FINAL
ENVIRONMENTAL ASSESSMENT
FOR
BORDER FENCE CONSTRUCTION AND ROAD REPAIR
NACO, COCHISE COUNTY, ARIZONA
JTF-6 OPERATION JT044-94

Prepared for:
Joint Task Force Six
Department of Defense
Fort Bliss, Texas

**FINDING OF NO SIGNIFICANT IMPACT
FOR THE
JOINT TASK FORCE SIX OPERATION JT044-94
BORDER FENCE CONSTRUCTION AND ROAD REPAIR
NACO, COCHISE COUNTY, ARIZONA**

Encls
1. Naco Culvert

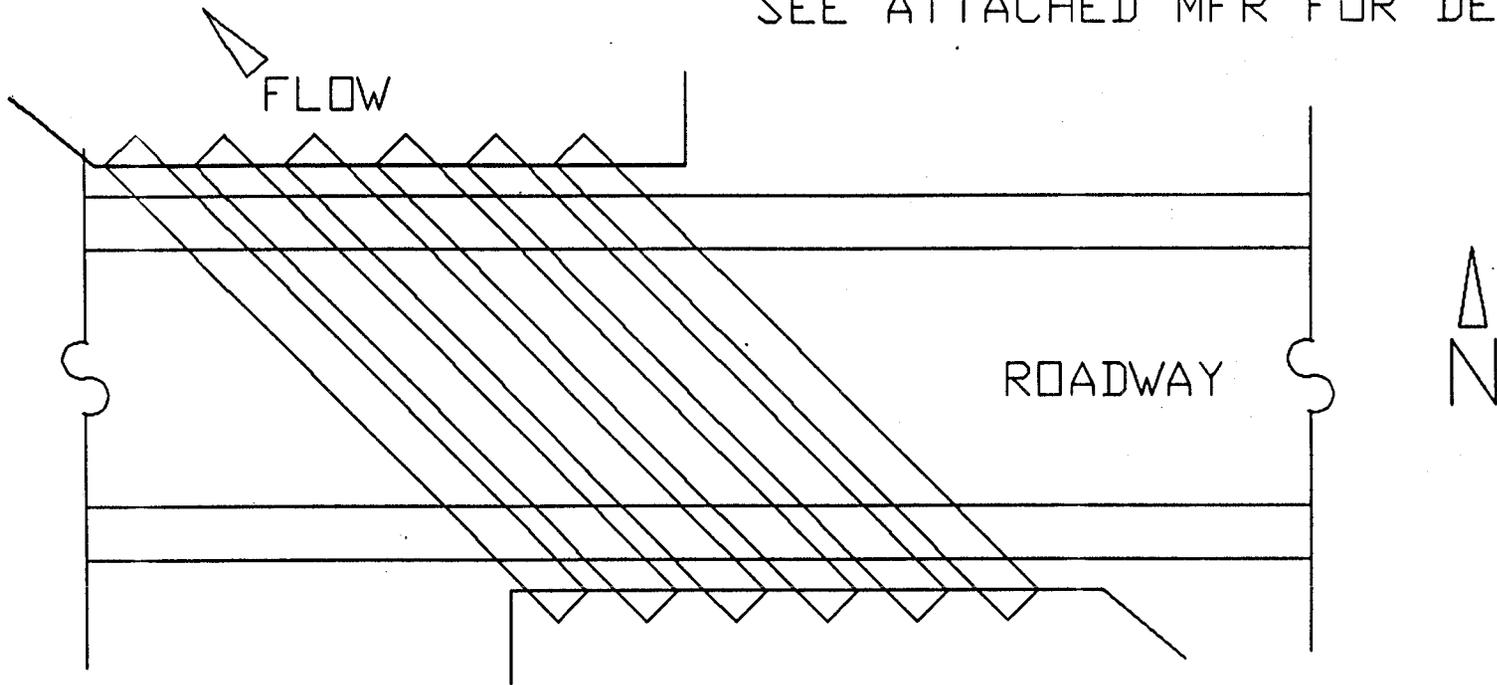
Response # 3. See JTF-6 letter dated March 22, 1994 to IBWC regarding design of the culvert/erosion control structures. Culverts are installed using design techniques to reduce erosion along the washes i.e. sand bags. Long term cumulative impacts to the drainages due to maintenance will be addressed in the Programmatic Environmental Impact Statement; however, maintenance activity will result in very minor impacts to the vegetation along the washes. Your comment regarding using permeable fills is noted and will be brought to the attention of JTF-6.

- a. 6 - 36" CMP culvert @ 60' long aligned with the nature flow of the wash.
- b. Minimum 18" cover
- c. 18" between CMP
- d. Concrete head walls either formed or bulky angular rubble w/concrete slurry.
- e. Minimum slope = 3.8%

2. All culverts will use bulky rubble w/concrete slurry around head walls and wash area for erosion control. Smaller culverts sited along the road will be constructed using similar erosion control measures. The head and tail walls are designed so that if the capacity of the culvert is exceeded, the water flows over the road with minimal erosion to the roadway.
